May 8, 2022

Subject: Draft Housing Element and related 4-4-22 zoning text amendments (Item 7-C on 5-9-22 Planning Board agenda)

Christopher Buckley, Chair
Preservation Action Committee
Alameda Architectural Preservation Society

2. Building Height Limit: Building height shall be regulated as follows:

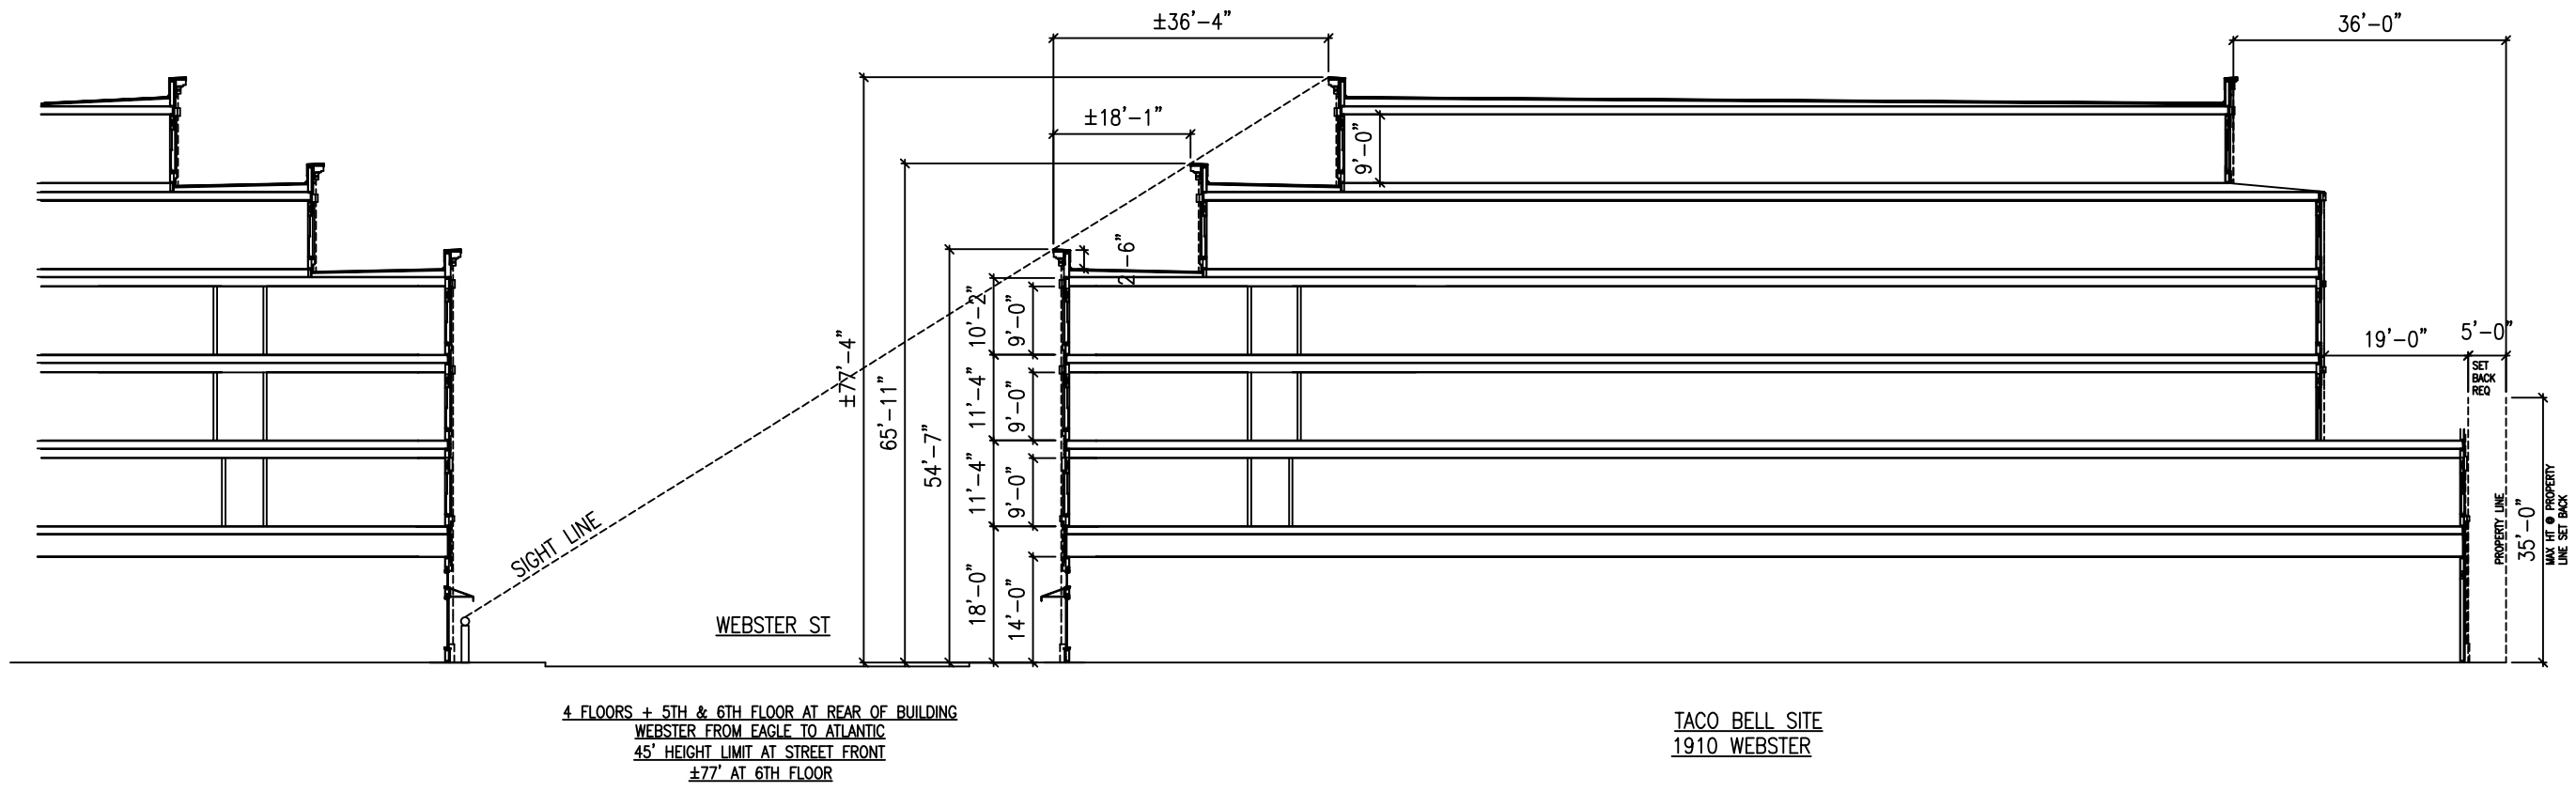
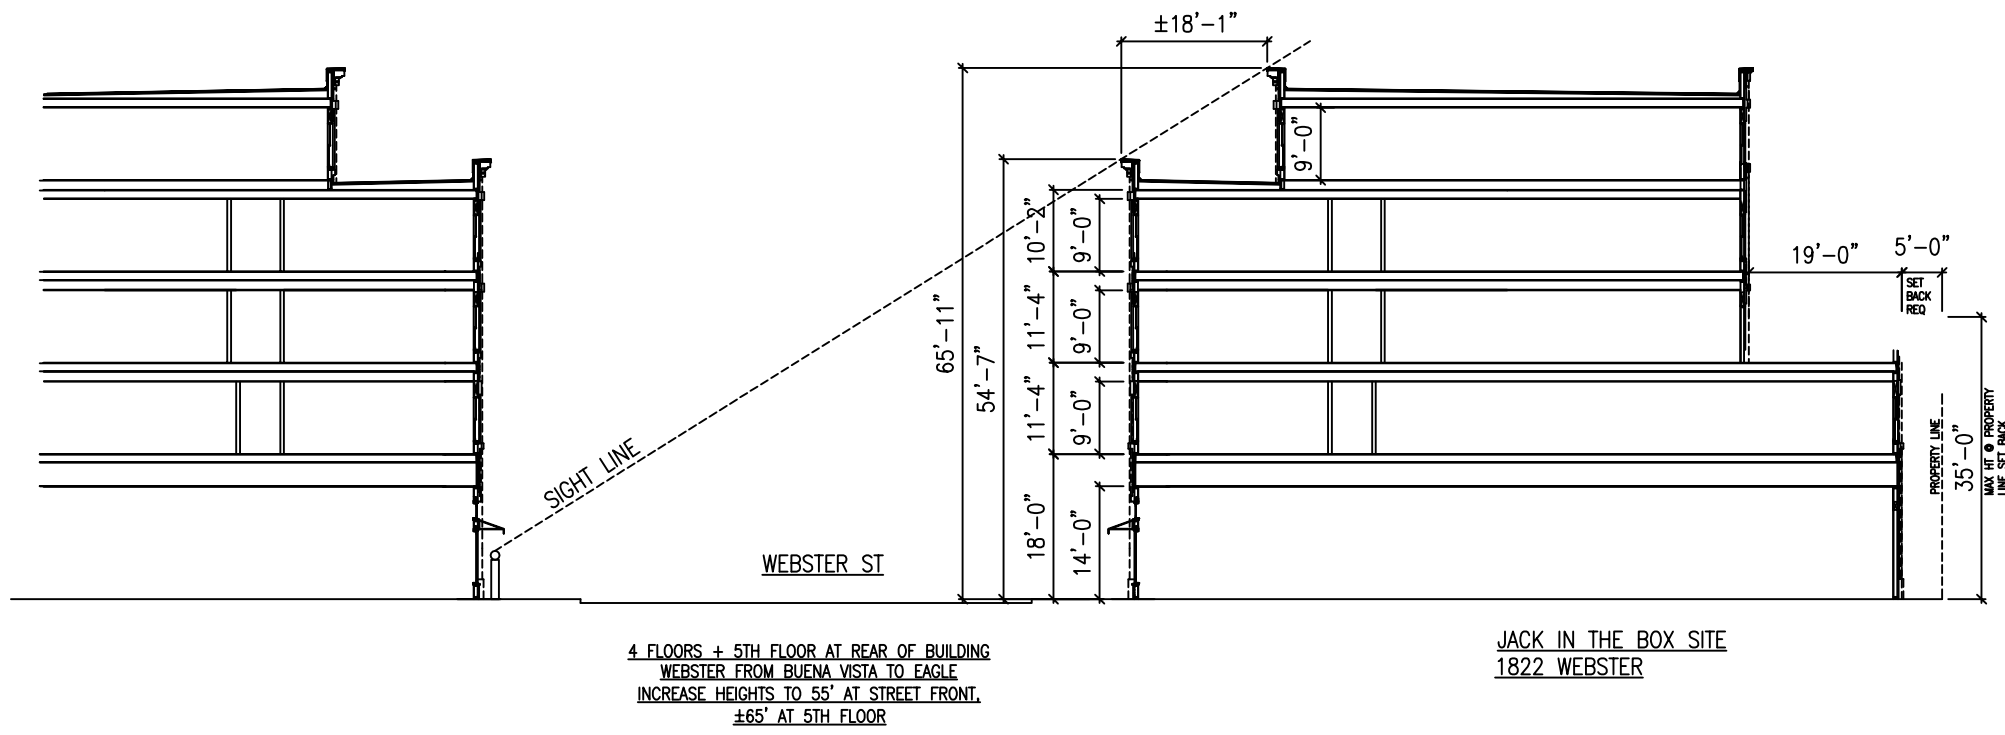
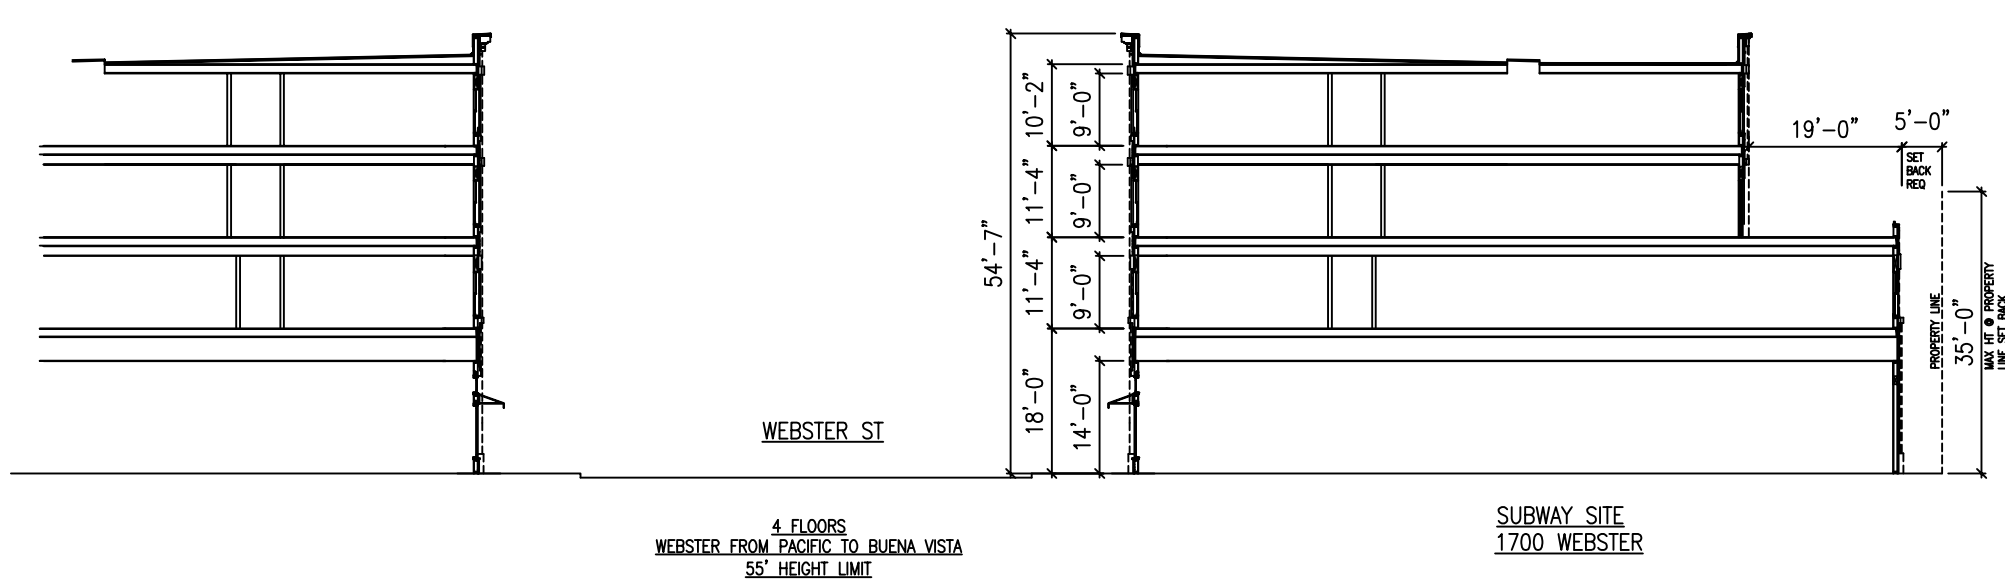
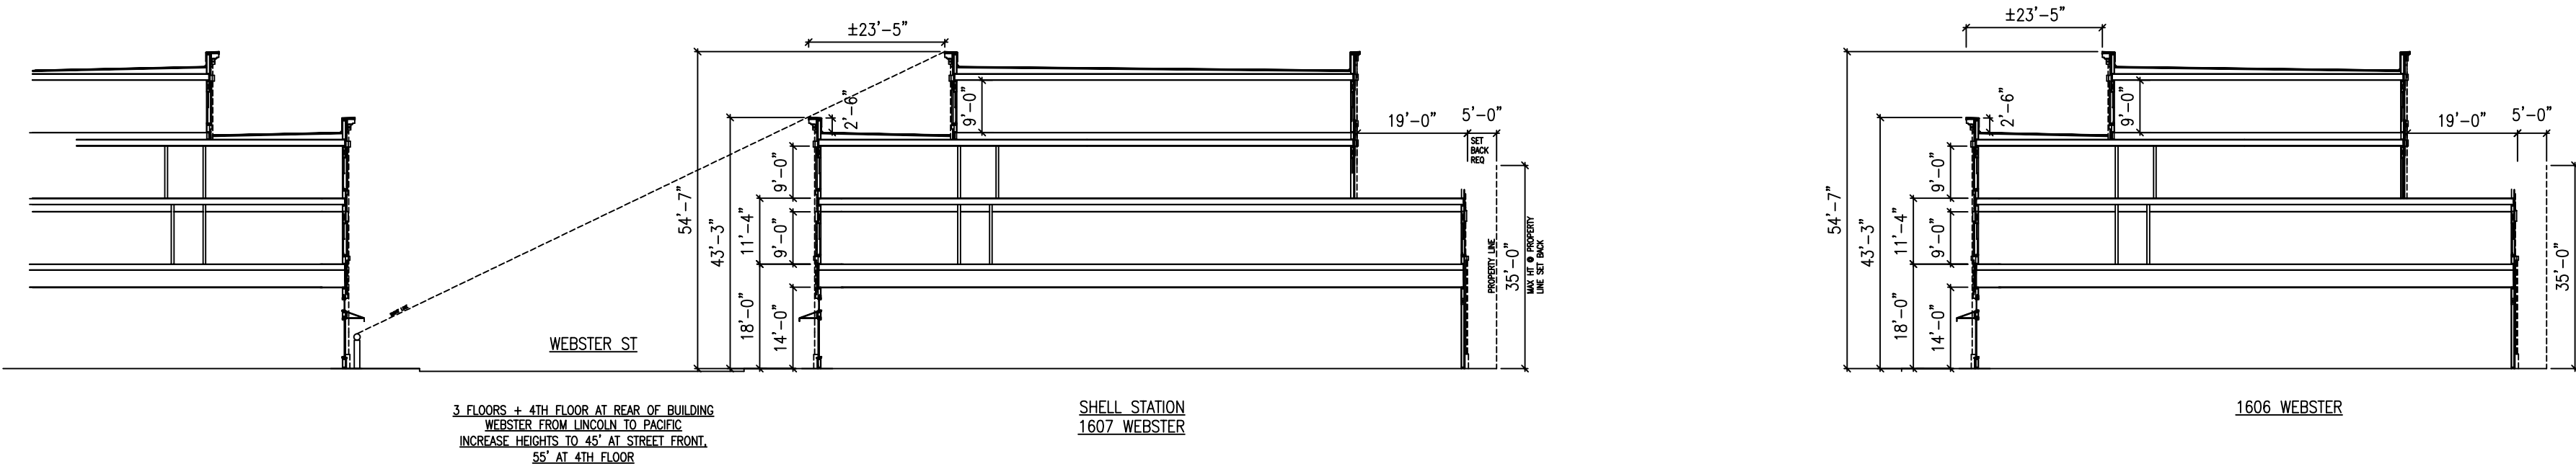
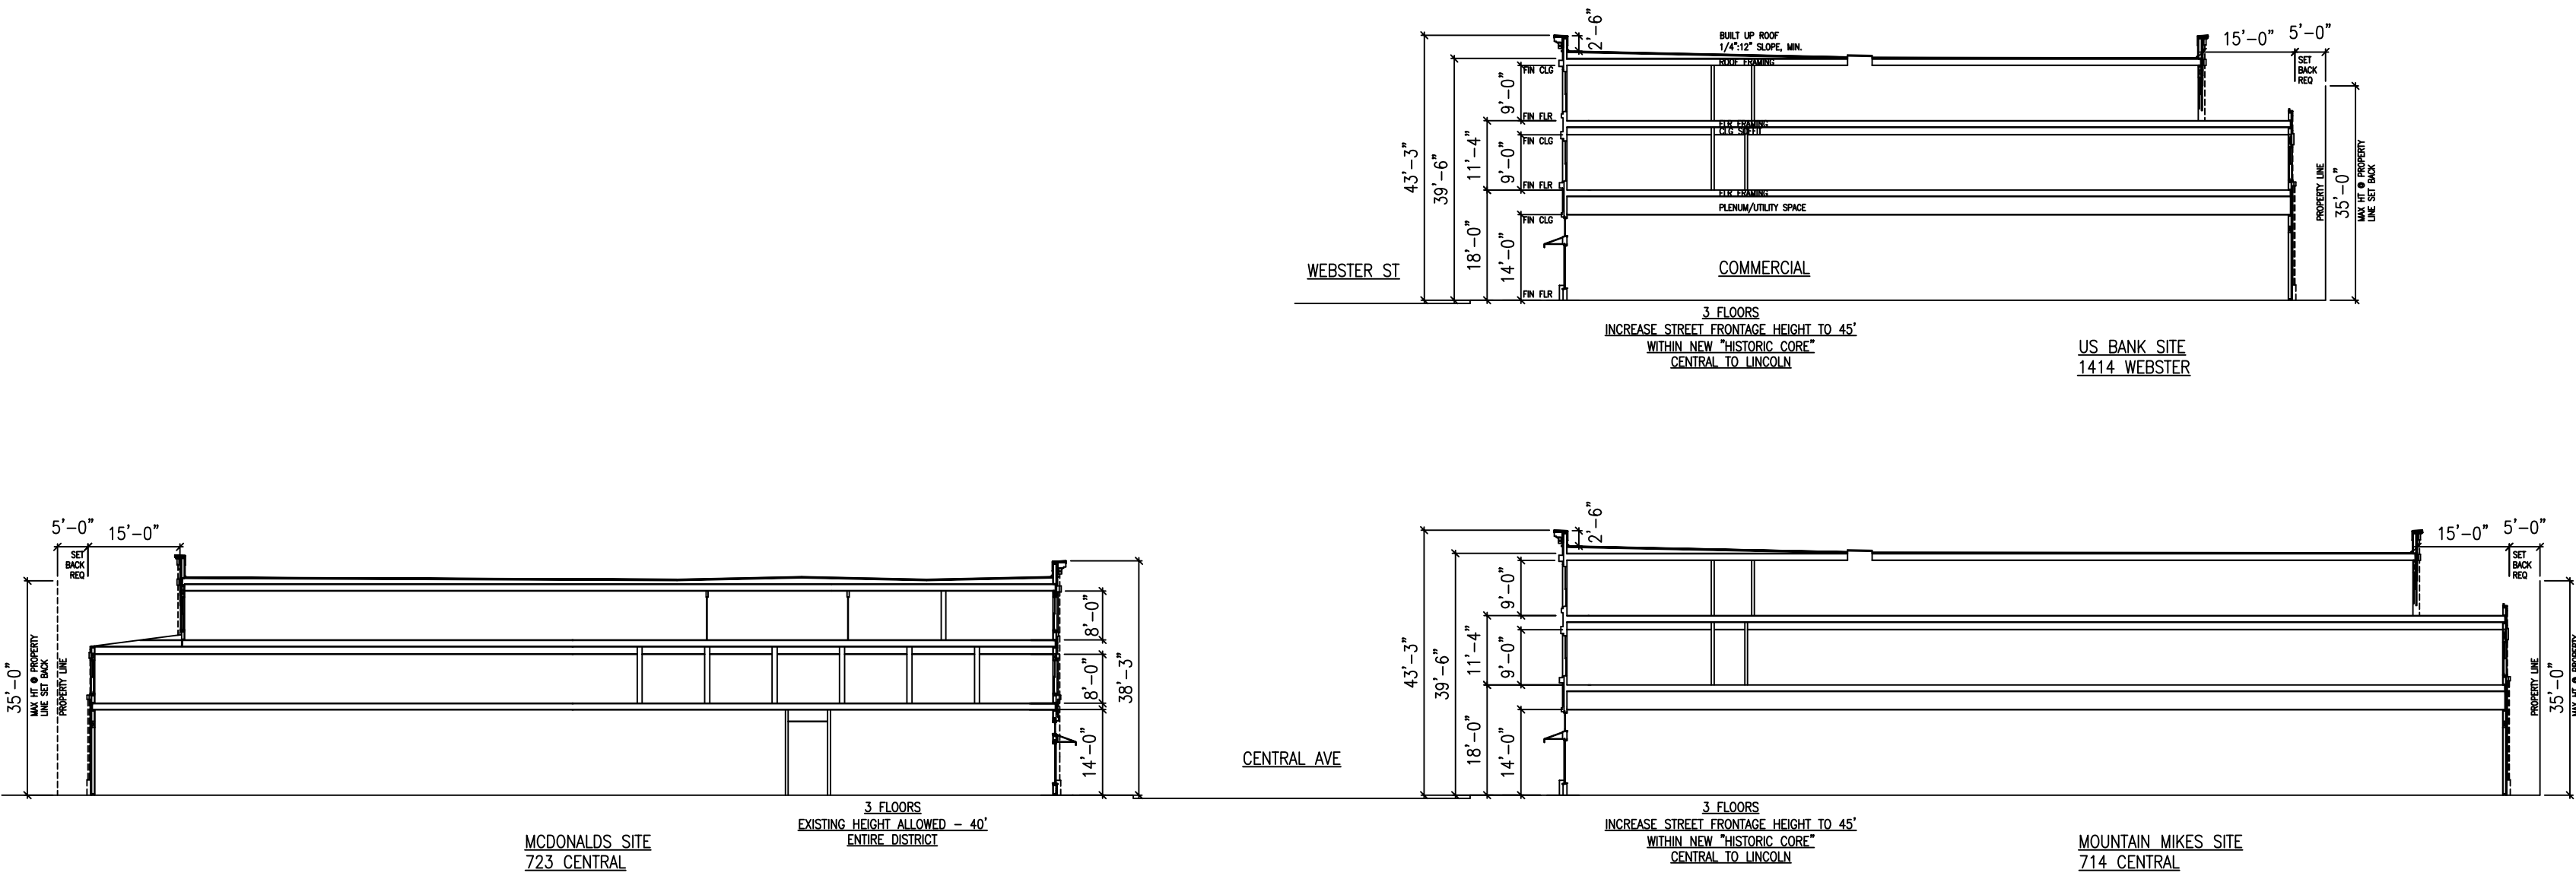
- Properties fronting onto the south side of Central Avenue - fifty five (55') feet, provided that any portion of the building that exceeds forty five (45') feet is set back at least ten (10') feet from the face of the building.
- Properties fronting onto Webster Street between Central Avenue and Lincoln Avenue, and properties fronting onto the north side of Central and south side of Lincoln - forty five (45') feet;
- Properties fronting onto Webster Street between Lincoln Avenue and Pacific Avenue and properties fronting onto the north side of Lincoln and the south side of Pacific - fifty five (55') feet, provided that any portion of the building that exceeds forty five (45') feet is set back at least ~~ten (10')~~ feet from the face of the building. *(e both front + rear PL)*

- Properties fronting onto Webster Street between Pacific Avenue and Buena Vista Avenue and properties fronting onto the north side of Pacific and the south side of Buena Vista Avenue - fifty five (55') feet; (SAME 24' SET BACK? & REAR?)

- Properties fronting onto Webster Street between Buena Vista Avenue and Eagle Avenue and properties fronting onto the north side of Buena Vista or the south side of Eagle- sixty five (65') feet, provided any portion of the building that exceeds fifty five (55') feet is set back at least ~~ten (10')~~ ^{18'} feet; and, (+ 24' SET BACK & REAR FT?)

- Properties fronting onto Webster Street between Eagle Ave and Atlantic Avenue and properties fronting onto the north side of Eagle or south side of Atlantic- eighty five ~~(85')~~ ⁸⁰ feet. w/ 18' SET BACK @ 5th FLR + 36' SET BACK @ 6th FLR + 24' @ REAR
